NUMBER: 08-035-17

3.6L Engine Wiring Harness Retainer Clip Replacement

This bulletin involves replacement of the Transmission Control Module (TCM) wiring harness retainer clip with a new retainer clip that will move the wiring harness away from right side exhaust heat shield.

2016 - 2017	(WD)	Dodge Durango
2016 - 2017	(WK)	Jeep Grand Cherokee

Fig. 1 Retainer To Be Replaced

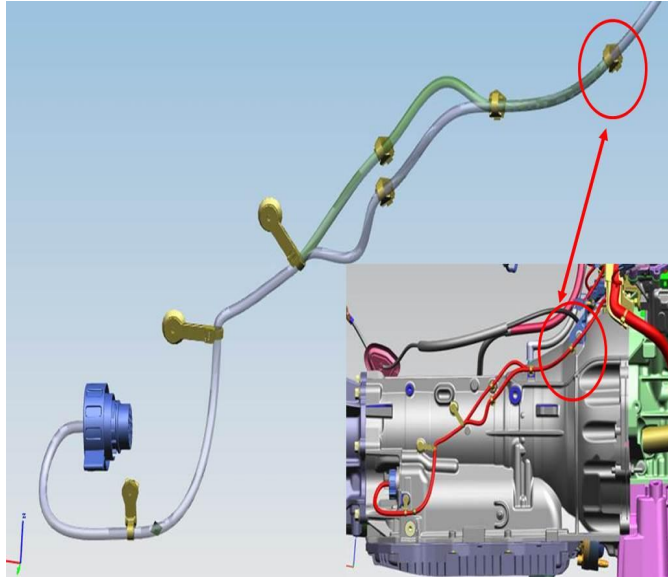
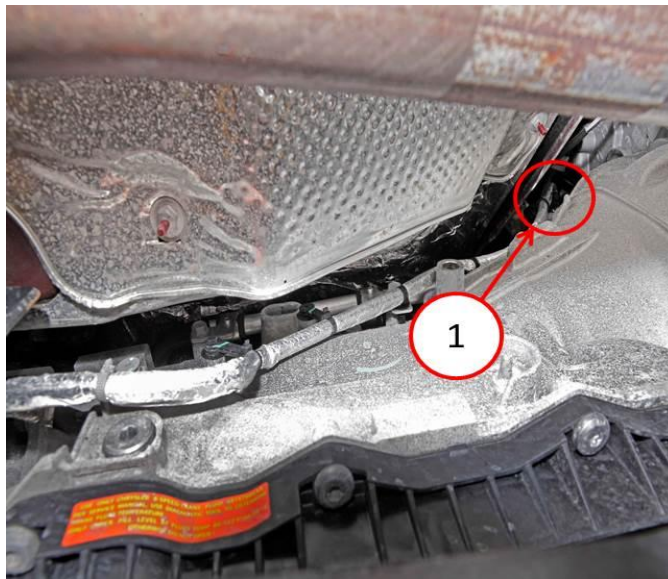
1. Lift and support the vehicle. Refer to the detailed service procedures available in DealerCONNECT> TechCONNECT under: Service Info> 04 - Vehicle Quick Reference> Hoisting> Standard Procedure.
2. Remove the forward retainer clip (Fig. 1) and (Fig. 2).

Fig. 3 Retainer After Replacement

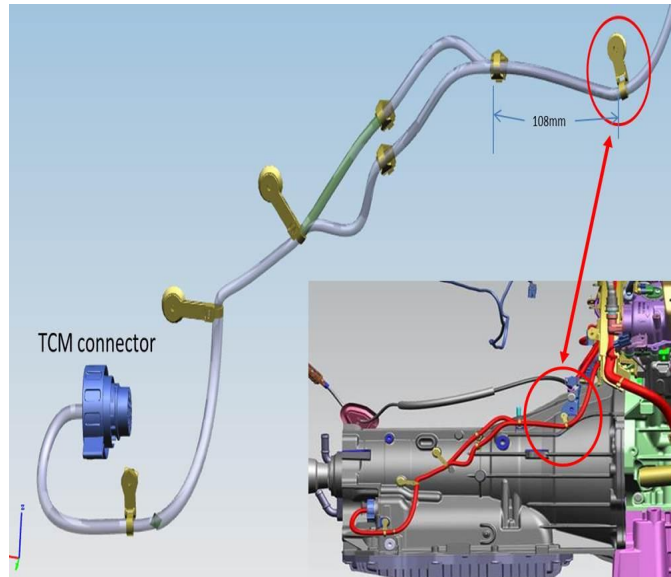
3. Inspect wiring harness for wear from chaffing from contact with heat shield.
4. Is there any wiring damage found?
 - a. YES>>> Repair the damaged wiring. Refer to the detailed service procedures available in DealerCONNECT> TechCONNECT under: Service Info 29 - Non-DTC Diagnostics/Circuit Testing Procedures/Standard Procedure. Continue with [Step #5](#).
 - b. NO>>> Continue with the Repair Procedure [Step #5](#).
5. Replace the retainer clip with new part (P/N is 68078700AE). Place the new clip 108 mm (4.25 in.) from split ([Fig. 3](#)).
